### STAFF RECOMMENDATION

#### **Docket LU-24-0014: O'Conor Access Road**

**Request:** Limited Impact Special Review for 1,254 cubic yards of non-foundational earthwork for construction of a new driveway to access the existing residence on an approximately 3-acre parcel at 254 Left Fork Rd.  
**Location:** 254 Left Fork Rd, parcel number 146130000021, approximately 0.7 miles north of the intersection of Sugarloaf Rd and Mountain Pines Rd, Section 30, Township 1N, Range 71W.  
**Zoning:** Forestry (F)  
**Applicant:** Andrea O'Conor (Owner)  
**Agents:** Gino Cornella and David Lucas

Figure 1

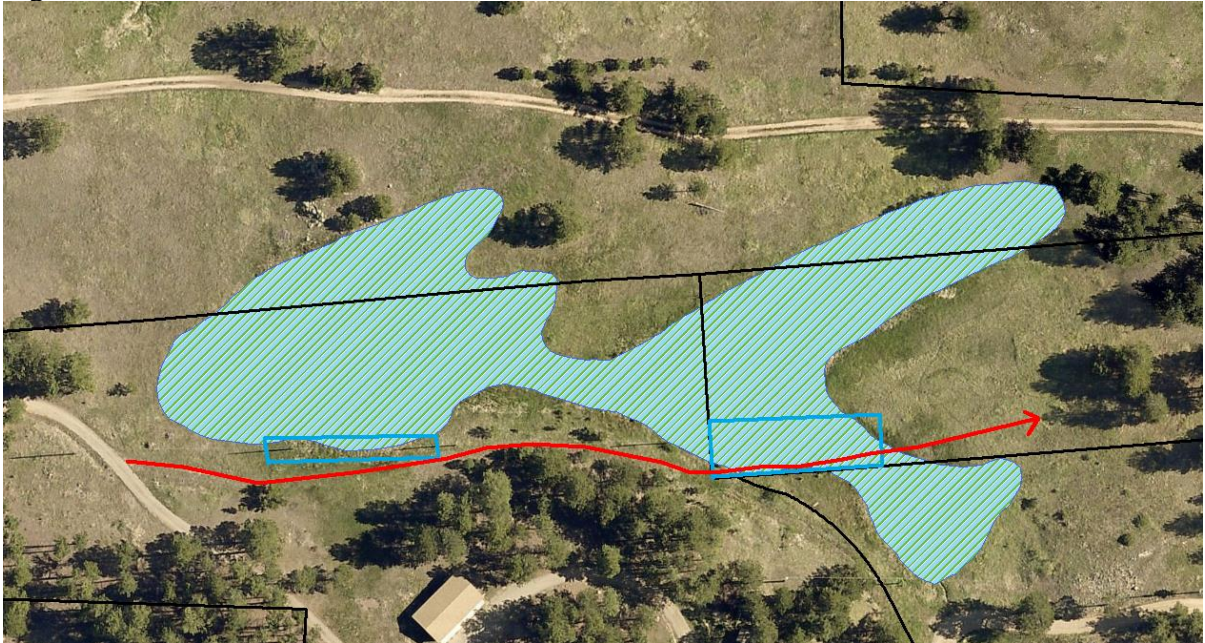
About the first half of the new driveway (western end) would be on the adjacent parcel, in upland and on a previously disturbed, old road grade. This portion should not result in significant impacts as long as construction on the northern edge of the drive does not enter the wetland area on the north (see fencing requirement below; and Figure 1, blue polygon on west.)

Staff notes that the Comprehensive Plan wetland mapping includes an automatic “buffer” on known wetlands. On Figure 1, a more accurate boundary of the wetland is presented.

For the eastern end of the new driveway, in upland, there also should not be significant impacts. However, in the middle of the driveway, the alignment crosses a drainage and wetland area. This site is staff’s main concern – blue polygon on east in Figure 1.

At the western wetland area, a construction fence must also be erected and inspected, showing the edge of the wetland area on the north side of the driveway alignment. For both fences, no construction or staging can encroach north of the fences.

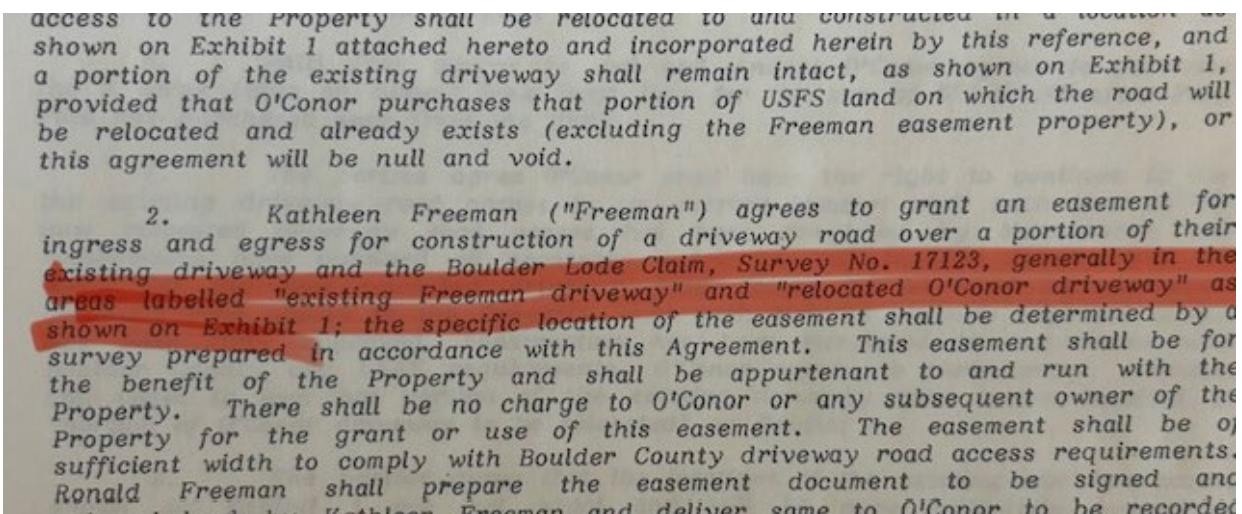
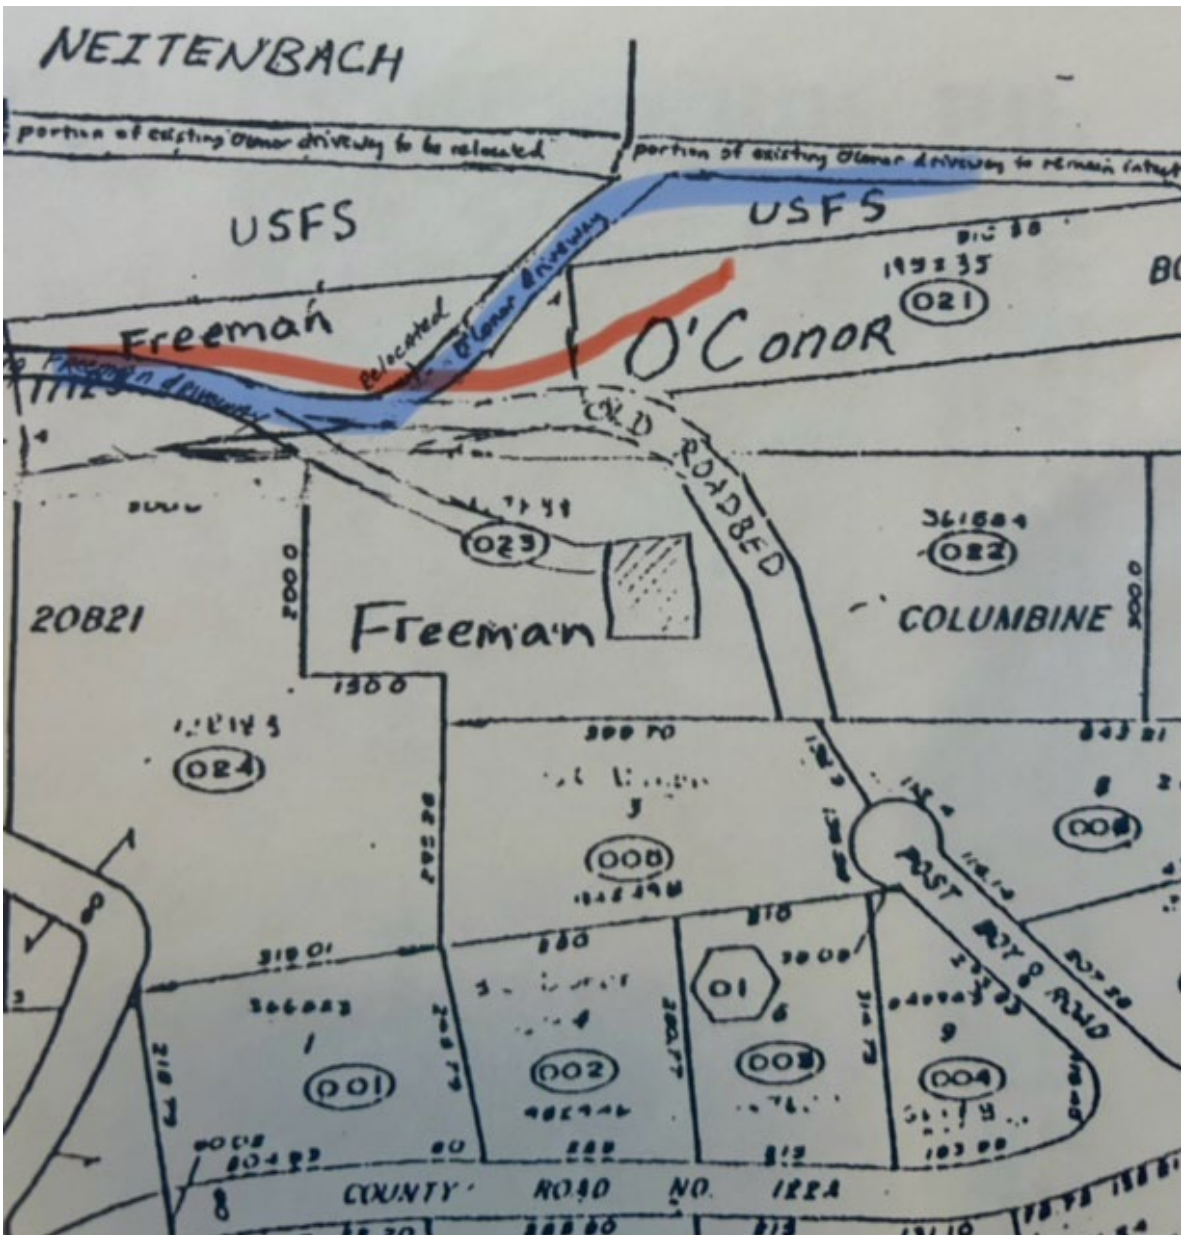
Interestingly I noticed on the Memorandum of Agreement/easement paperwork from when it was granted by my mom Kathy (written up by my dad-he was very sick and passed away soon after so put it in my mom's name) the map showed a different path for the construction of a driveway which is not where the surveyor stakes are located. The easement map called for the road to be north of the heart of the meadow, not the low point/center of it, sparing several trees and lots of water/peet.

(The Orange lines are the Surveyors stakes). Interested in what the environmental/ biological: geotechnical engineer /Parks Open Space opinion is?
